Service Bulletin

No. : MZ05-012

Model: SR4500

Subject: Correction of the Service Manual Mechanical parts list.

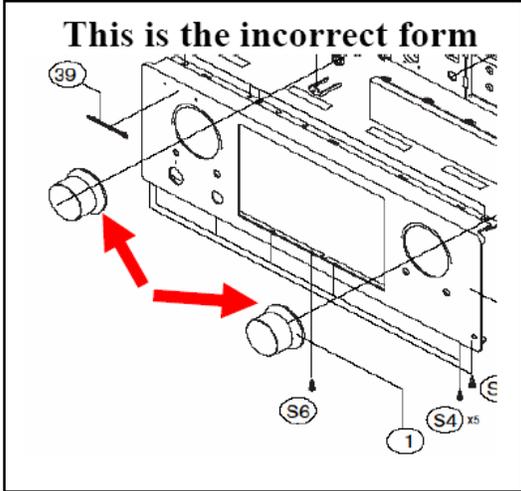
Symptom: The part number in the service manual for the Volume Knob Assembly is incorrect.

Solution: Use the new number listed in the Parts section.

Ref #	FORMER		NEW	
	Description	Part Number	Description	Part Number
1	VOLUME KNOB ASS'Y (BLACK)	00M28AW154010	VOLUME KNOB ASS'Y (BLACK)	00M27AW154010
1	VOLUME KNOB ASS'Y (SILVER)	00M28AW154030	VOLUME KNOB ASS'Y (SILVER)	00M27AW154030
